CITY OF RAMSEY LAND USE APPLICATION
TECHNICAL REVIEW FILE

DATE	DECEMBER 30, 2016	PROJECT ADDRESS	WEST OF GERMANIUM ST NW, SOUTH OF TROTT BROOK
PROJECT. TITLE	BROOKVIEW ESTATES SKETCH PLAN		
ESCROW #			
DEPARTMENT:	Community Development: Planning Division (Zoning Code)		
TECHNICAL REVIEWER:	Name: Eric Maass, Consultant Planner Phone: (763) 576-4306 Email: EMaass@wsbeng.com

We offer the following comments regarding the Sketch Plan submittal for Brookview Estates as it relates to the City's Zoning Code. Sketch Plan submittal consists of one (1) sheet, prepared by LHB, Inc.

Sketch Plan Sheet – Items that need addressing prior to possible application for Preliminary Plat.

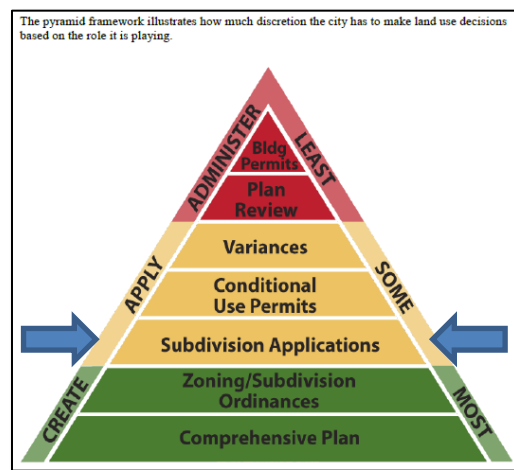
- Need to add property owner and address to sheet.
- Show lot width measurement for each proposed lot. Lot width measurement to be shown at the building setback line. Note that each lot is required to have a minimum lot width of 200 feet.
- Wetlands – A wetland delineation will need to be completed. A setback of 16.5 feet will need to be provided around any identified wetlands. At the time of Preliminary Plat application, an exhibit should be included that clearly indicates the minimum required setback and accompanying easement encumbrance related to any identified wetlands. Note that area within the wetland setback should also be encumbered by the easement.
- Applicant will be required to complete the below table to indicate the requested deviation from the base R-1 Residential (Rural Developing) zoning requirements:

- Indicate total development acreage, acreage within proposed right-of-way, and proposed density of the development.
- Indicate location of both primary and secondary septic system locations.

- This project will trigger review by the Lower Rum River Watershed Management Organization (LRRWMO) for both the wetland delineation and also the stormwater calculations due to more than one acre being disturbed. The application packet to be submitted to the LRRWMO must be submitted and reviewed first by the City prior to it being submitted to the LRRWMO.

- Provide names for proposed roadways.
- Labeling – include “Block” where Blocks 1 and 2 are identified. Block 1 is signified twice.
- Pedestrian trails – an access easement should be explored with the intention of providing public access to the 14 acres proposed to be deeded to the City as Outlot A as it is intended that a trail will be developed along the entirety of the Trott Brook.

- Steep Slopes – Lots 5 and 6 of Block 1 encroach upon existing steep slopes. The Applicant should consider revising Lots 5 and 6 of Block 1 so that the rear of the lots stay roughly between the 890 and 900 contours.

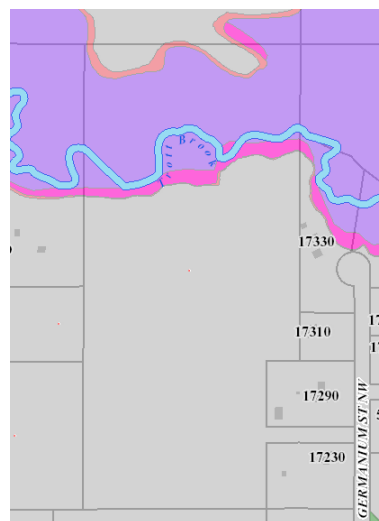
Wetlands. A wetland delineation will need to be completed for the property. Any wetlands identified will need to be encumbered with drainage and utility easements on the Preliminary and Final Plats. The project will be subject to review by the Lower Rum River Watershed Management Organization (LRRWMO) regarding both the wetland delineation as well as stormwater calculations. Note that City Code now requires a sixteen and a half foot (16.5') setback from a wetland edge and that setback area be encumbered with drainage and utility easement. *At the time of Preliminary Plat application, an exhibit should be included that clearly indicates the minimum required setback and accompanying easement encumbrance.*

Floodplains. There are floodplains within the boundaries of the project area, including both Floodway and Floodfringe. There shall be no fill placed within the Floodway (purple shading).

As proposed, the lots are laid out in such a fashion that each of the home sites is located in the upland area of the property.
